PES/NPEC SC-4: Working Group 4.6 - Preferred Power Supply Meeting Minutes for S20-01

**Charlotte, NC
January, 27th, 2020**

IEEE 765-2012 proposed revisions were presented. See Attachment 3 for full description of revisions.

IEEE 765-2012 Proposed Revision

Figure 1 - PPS interface diagram

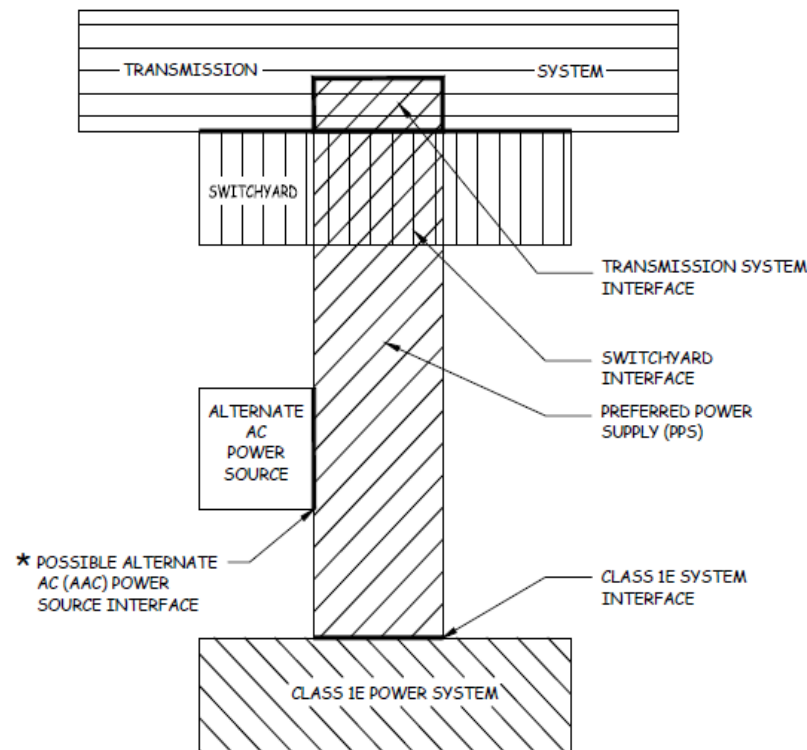
- ❑ No technical changes were made, reproduced in AutoCAD
- ❑ Included the * note which was previously left of the figure in 765-2012
- ❑ PAR Authorization: “update PPS design figures and graphics for typical station designs and consider adding clarification for general and specific design criteria”

Figure 2 - An example of an acceptable PPS design

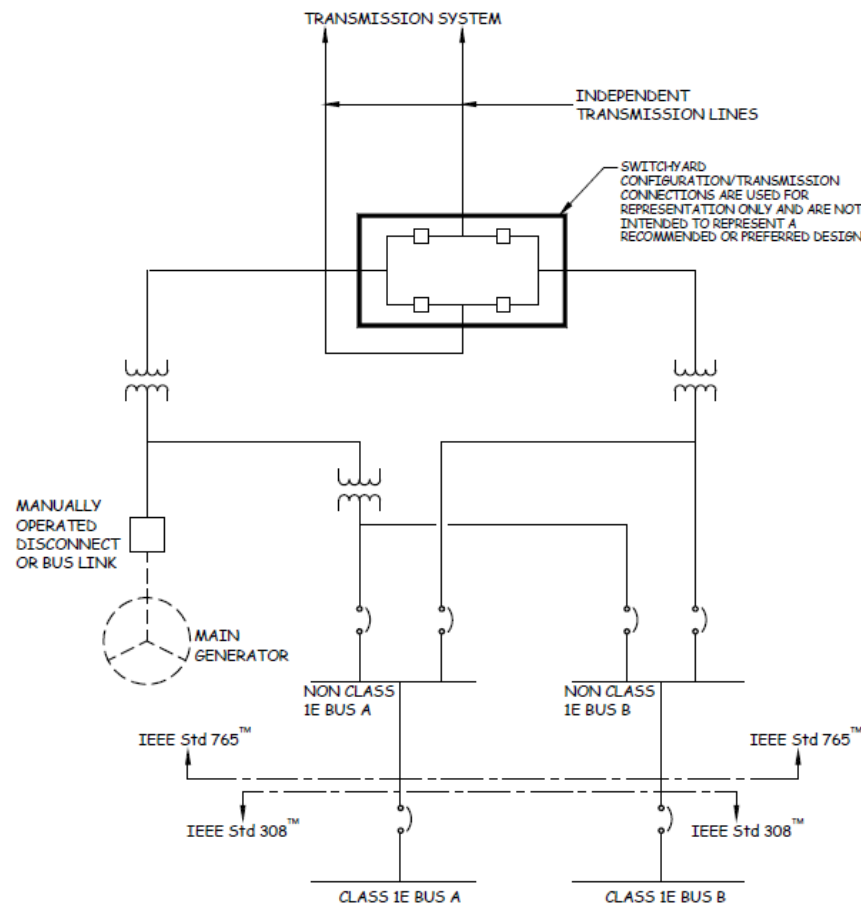
- ❑ No technical changes were made, reproduced in AutoCAD
- ❑ Included the note for switchyard configuration "Switchyard configuration/transmission connections are used for representation only and are not intended to represent a recommended or preferred design"
- ❑ PAR Authorization: "update PPS design figures and graphics for typical station designs and consider adding clarification for general and specific design criteria"

Comment: Figures 2, 3, and 4 each show an acceptable configurations for the PPS. Each configuration has a ring bus implying that this is the only acceptable switchyard configuration.
- Such configurations as main and transfer along with breaker and half schemes should also be acceptable. Address in the wording not necessarily the diagrams.

Solution: Updated figures with note (see above)

Figure 3

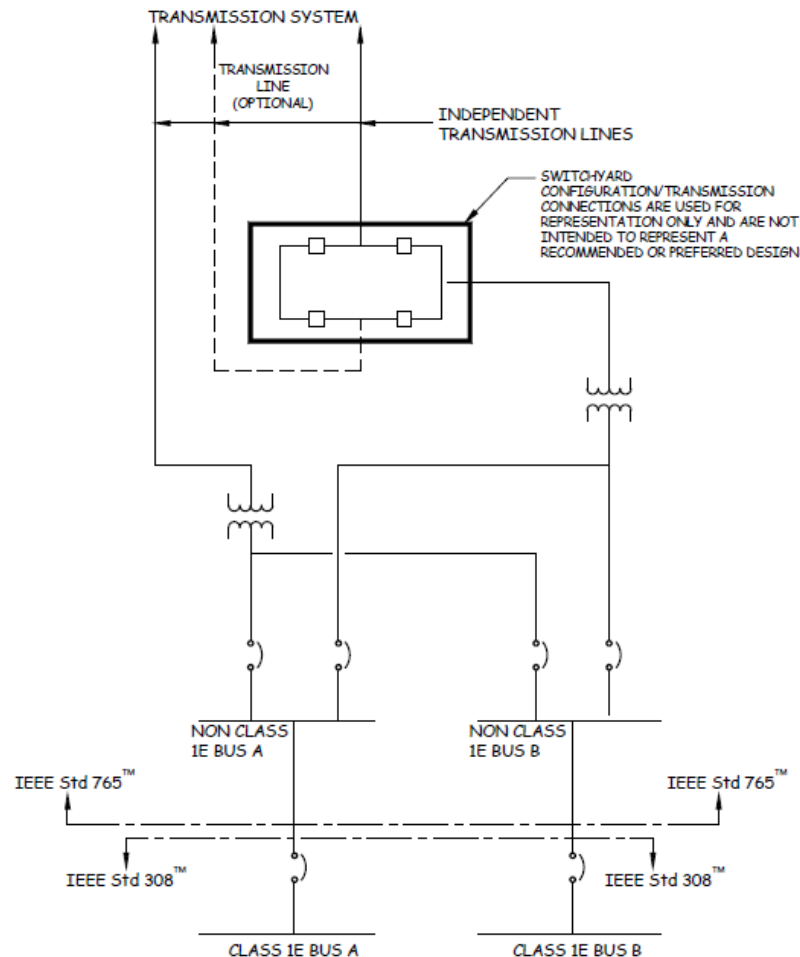
- ❑ No technical changes were made, reproduced in AutoCAD
- ❑ Included the note for switchyard configuration "Switchyard configuration/transmission connections are used for representation only and are not intended to represent a recommended or preferred design"
- ❑ PAR Authorization: "update PPS design figures and graphics for typical station designs and consider adding clarification for general and specific design criteria"

Figure 4

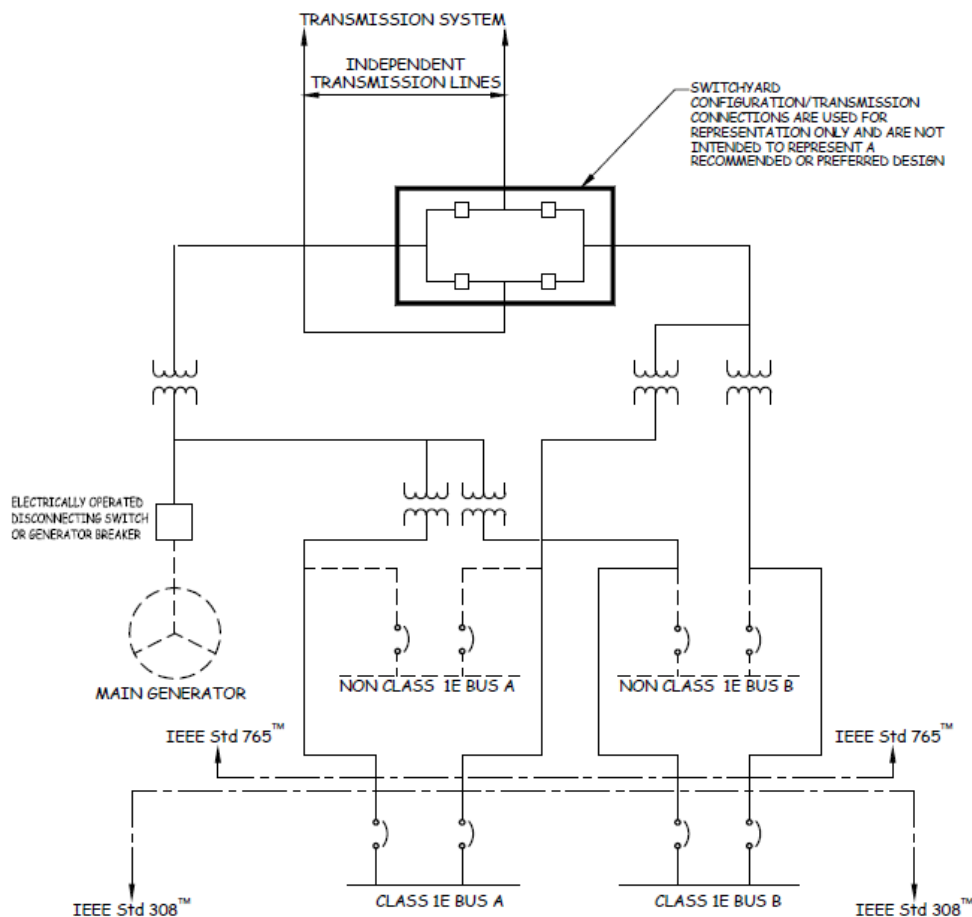
- ❑ No technical changes were made, reproduced in AutoCAD
- ❑ Included the note for switchyard configuration “Switchyard configuration/transmission connections are used for representation only and are not intended to represent a recommended or preferred design”
- ❑ PAR Authorization: “update PPS design figures and graphics for typical station designs and consider adding clarification for general and specific design criteria”
